Architectural Review  
and Historic Preservation Board  
Agenda Report

File: AR 20-05

RE: Architectural Review 20-05 (Bloom Energy)  
1531 Esplanade, APN 003-024-005 and 003-023-024, et al  
Revised Plans

**OVERALL SITE PLAN**  
 SCALE: 1" = 30'

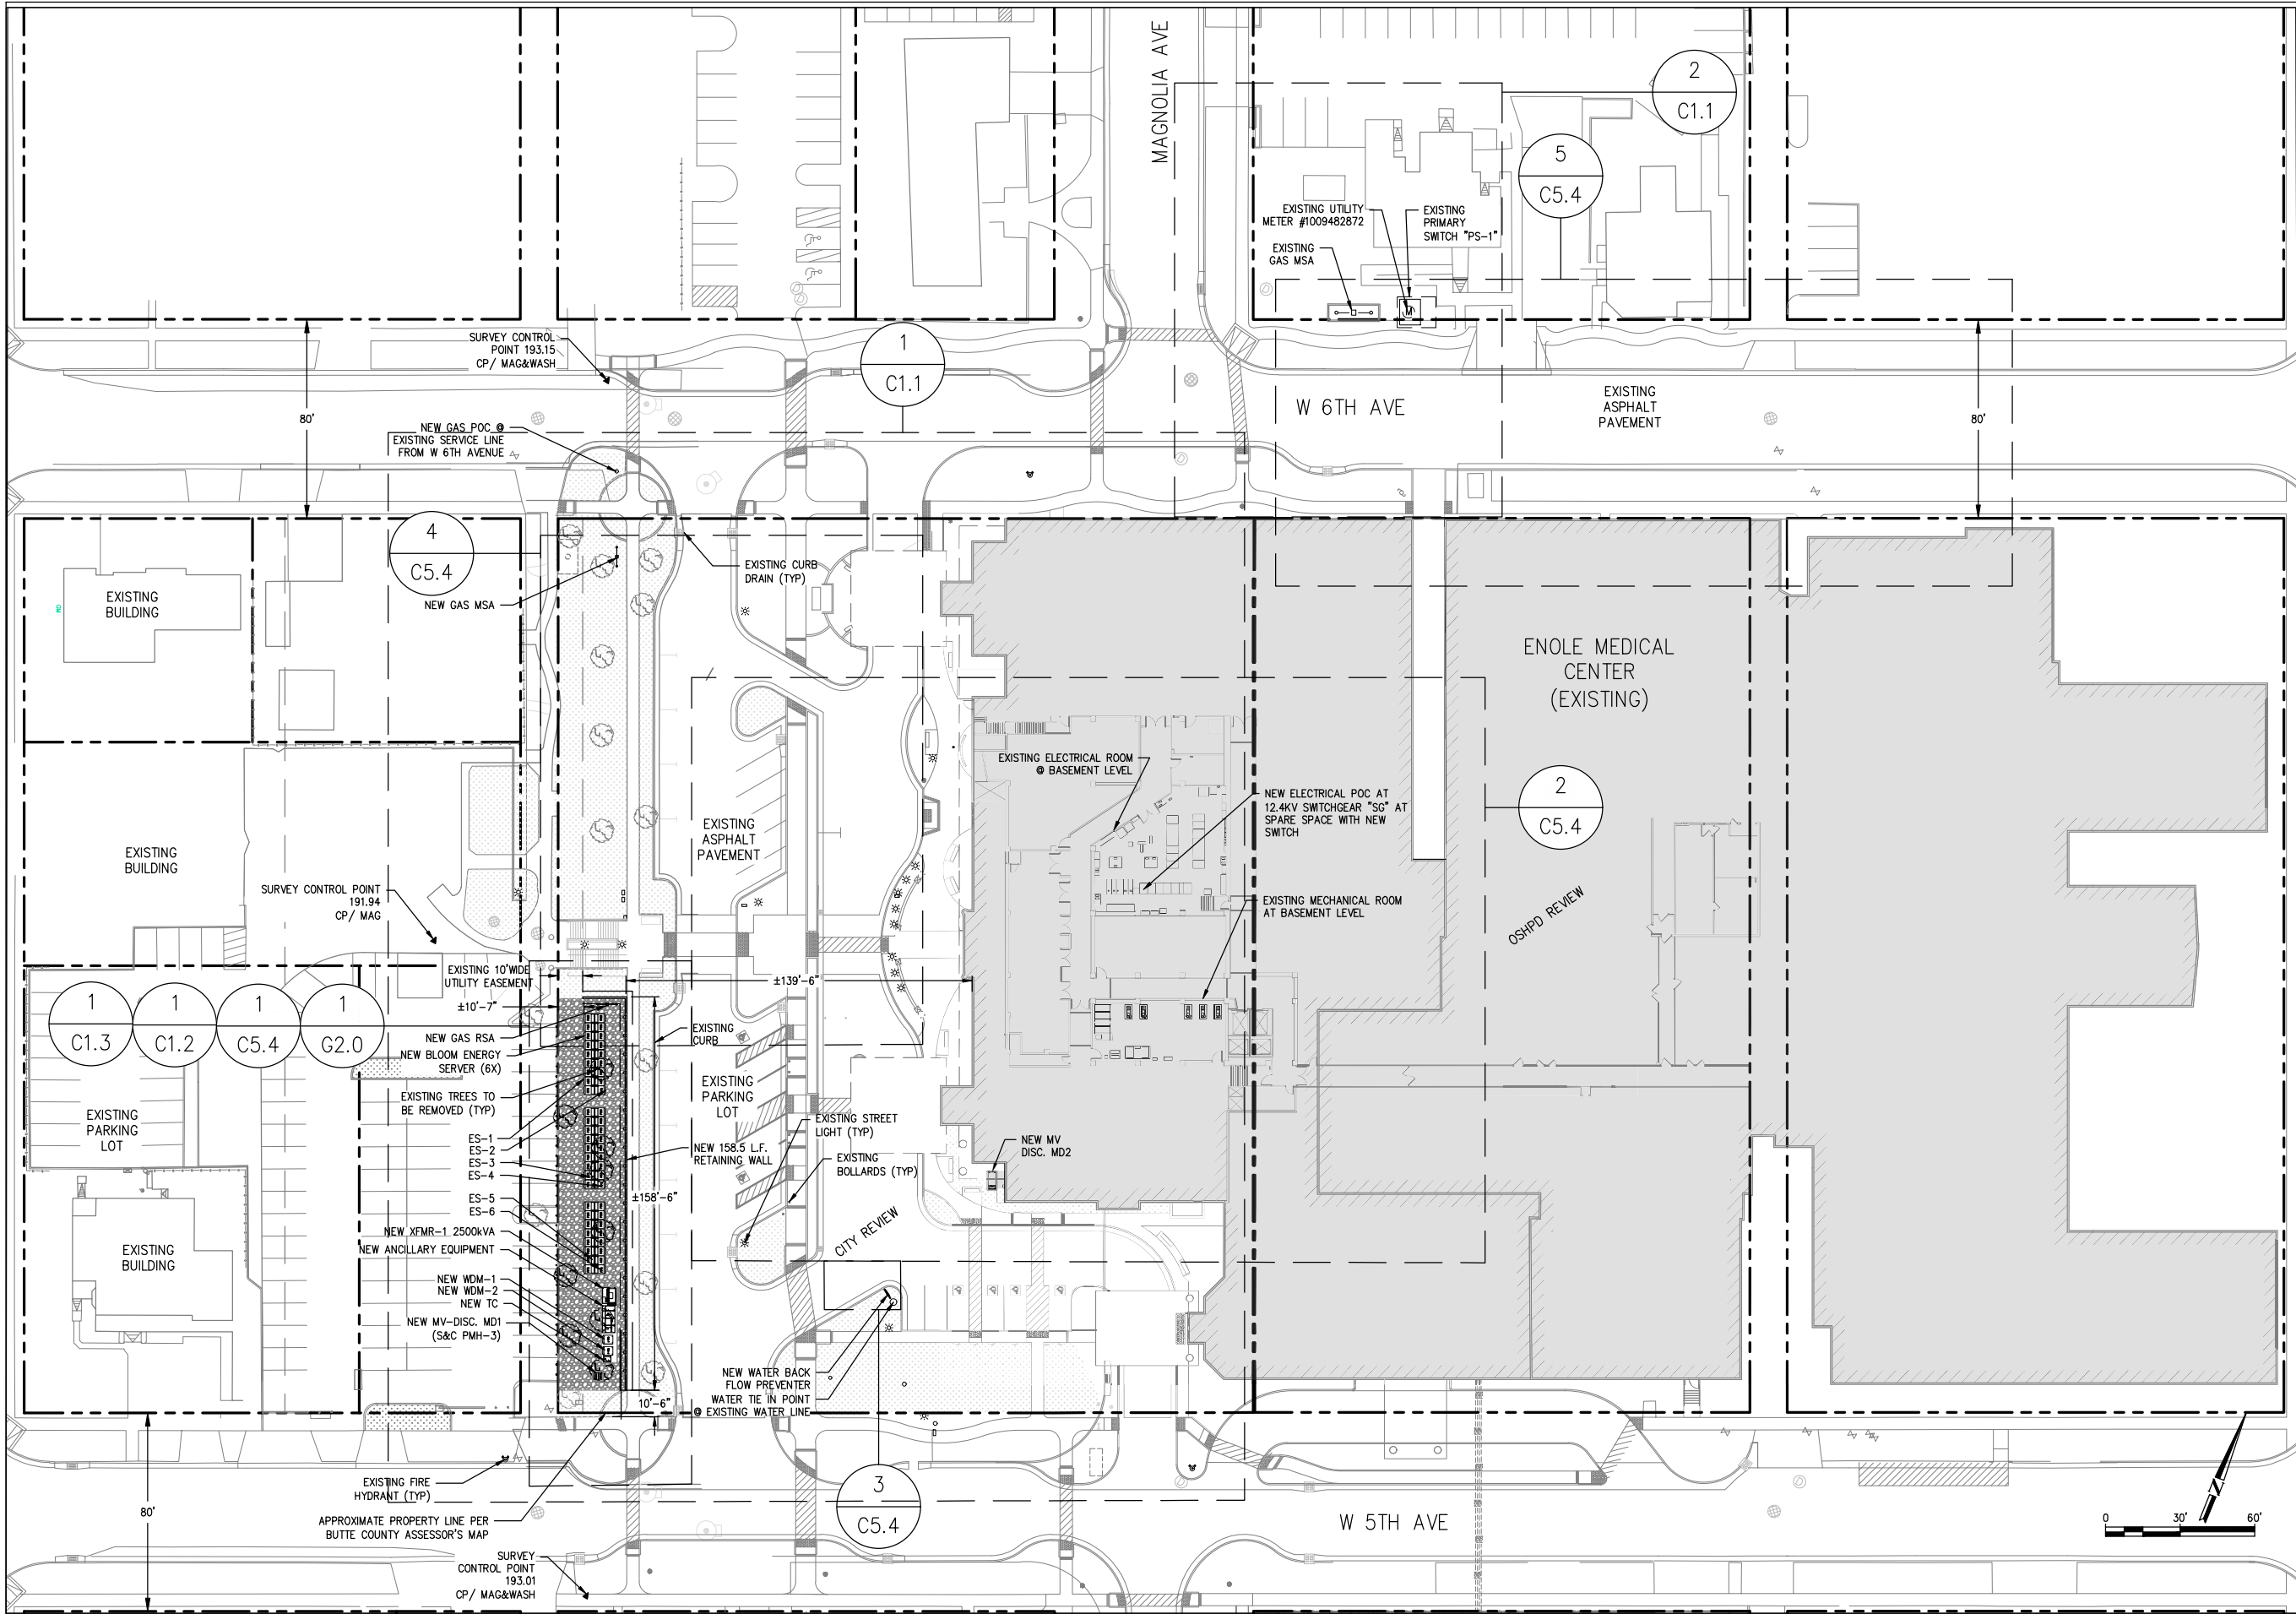
The proposed fuel cells would be set back approximately eleven feet from West 5<sup>th</sup> Avenue and would not alter the parking area or the formal garden portion of Enloe Park (see **Attachment B**, Site Plan). The fuel cells require no additional parking.

SHEET TITLE  
**SECTION DETAIL**

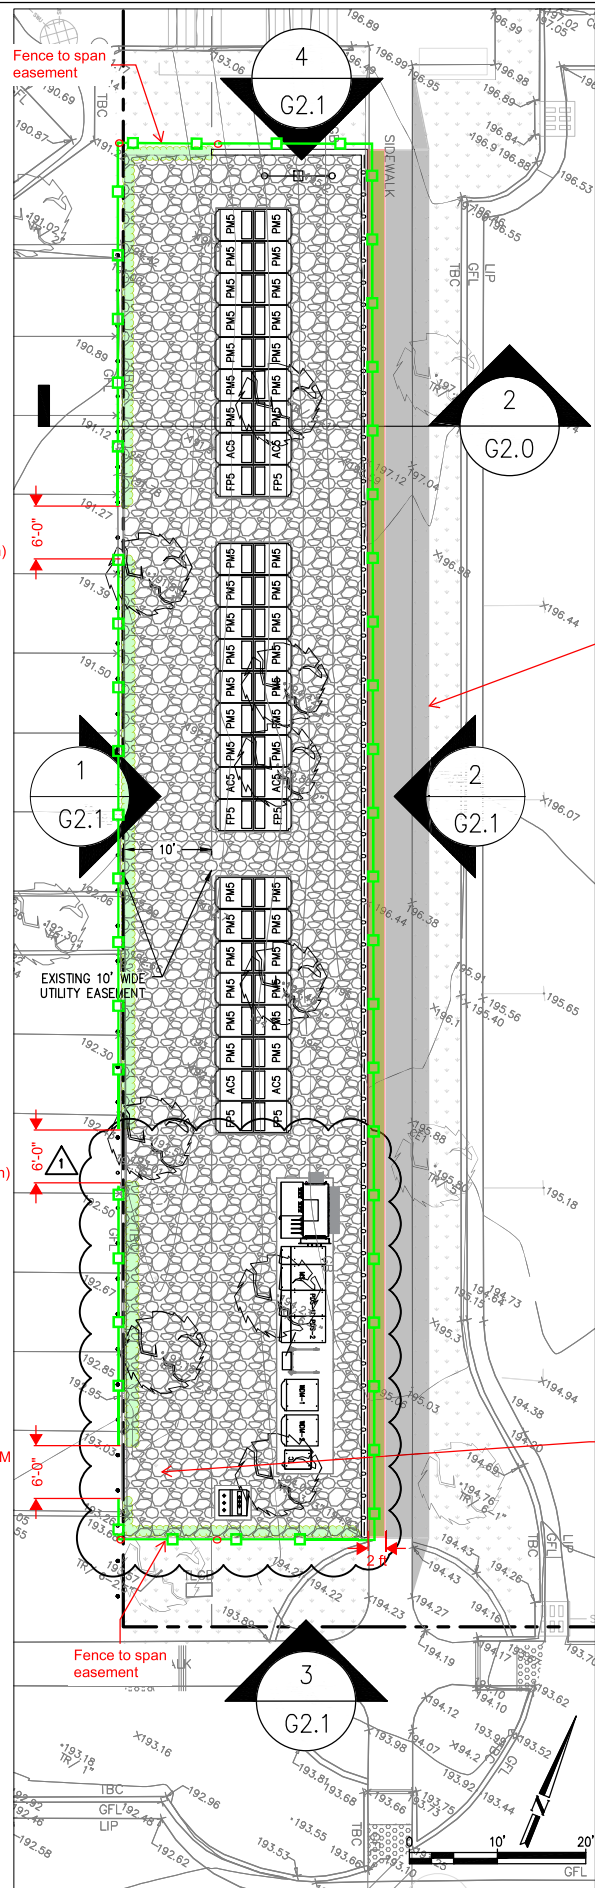
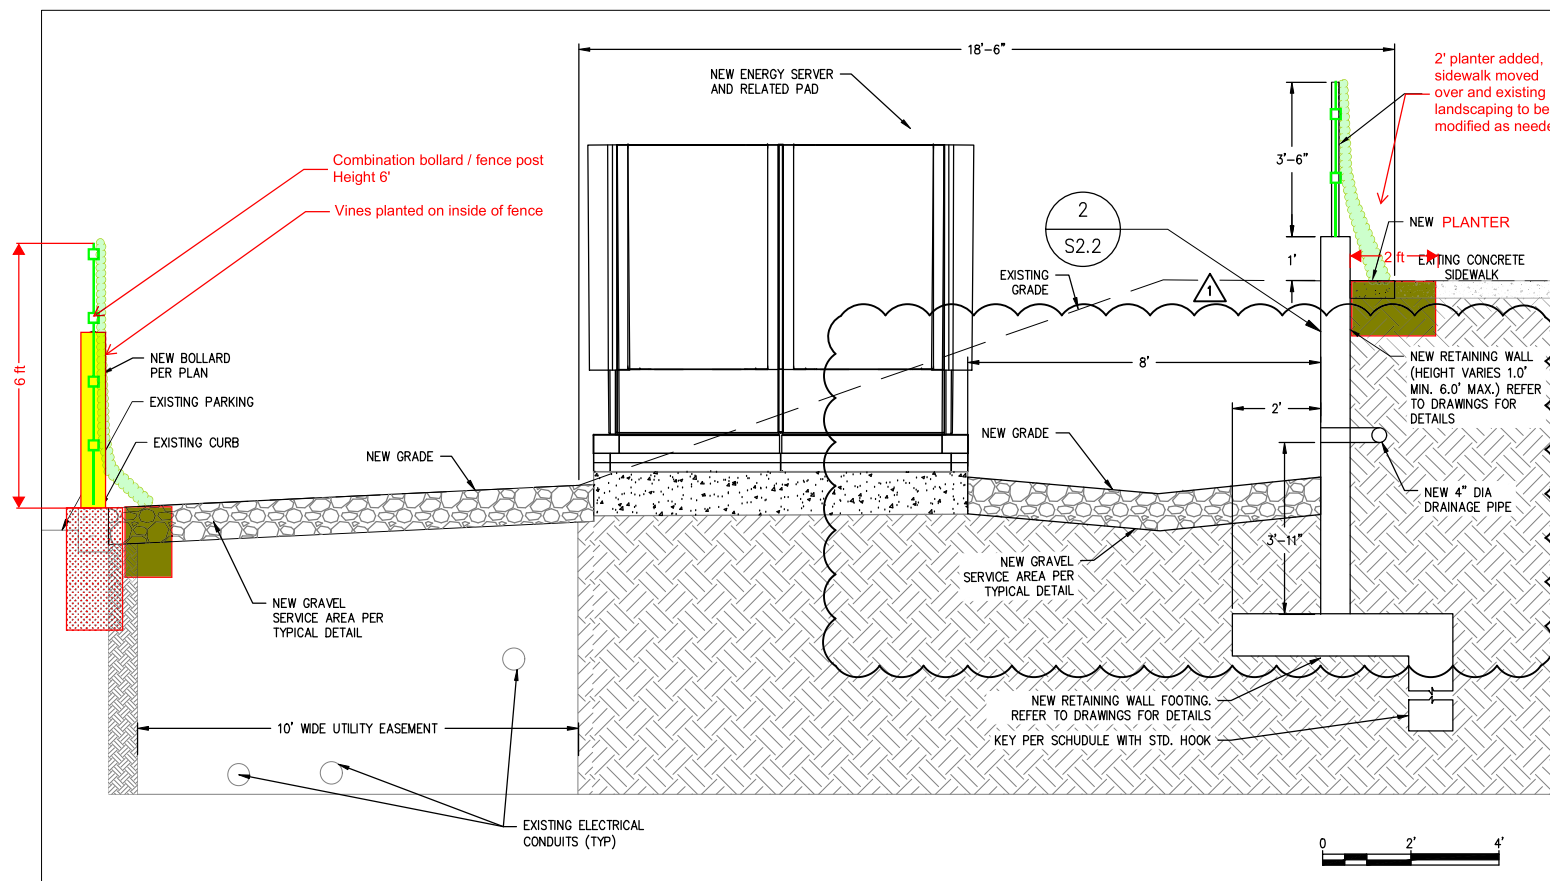
site detail. Revisions respond to both aesthetic and noise concerns raised by neighbors and included as supplemental materials in **Attachment H** and would support compatibility with the neighborhood.

In response, the applicant provided revised plans. The revised plans extend a living fence around the entire installation of the fuel cells, which would serve to minimize both aesthetic and noise impacts.

The second is the issue of noise. Though the living fence will not be solid or opaque, it will have noise-reducing properties inherent to any structure due to noise's inherently physical properties. Condition #5 requiring sound-attenuating material to be installed on the retaining wall behind the units has been added to contribute to noise reduction.

5. Building plans shall include and prior to permit final the applicant shall install on all sides of the concrete retaining wall that face the fuel cells noise-attenuating acoustic material such as baffles or panels or outdoor acoustic tiling. Staff shall field-verify such an installation prior to the operation of the Fuel Cells.
